Garrane Green Energy Project Limited

ACP-323635-25

9 no. wind turbines, grid connection, an energy storage facility and all associated site works. Ballynagoul, Creggane and Garrane, County Limerick.

Your Ref: **ACP-323635-25** Our Ref: **SID-LK-2025-023**

Figure 4—Excerpt from Google Earth imagery (dated March 2016) showing location for T09. Known non-Statutory SMR sites are shown in blue; three additional potential ring-barrows and a rectilinear earthwork are shown in red.

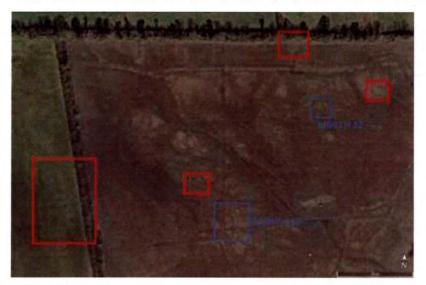
Google Earth imagery from March 2016 (Figure 4) shows three further potential ring-ditches within the field where T09 would be located (ITM: 554109, 627898; 554190, 627865; 554014, 627780). They range in diameter from c. 6 metres to c. 12 metres. These three sites are in addition to the two known non-Statutory SMR sites (LI047-112----; LI047-113----). While none of the sites appear to be within the footprint of T09 or its associated infrastructure, their close proximity would make them vulnerable to direct impacts from construction activity. Full exclusion zones of appropriate size and scale would be need to be put in place and secured/demarcated to ensure the preservation in situ of these sites during construction and decommissioning phases.
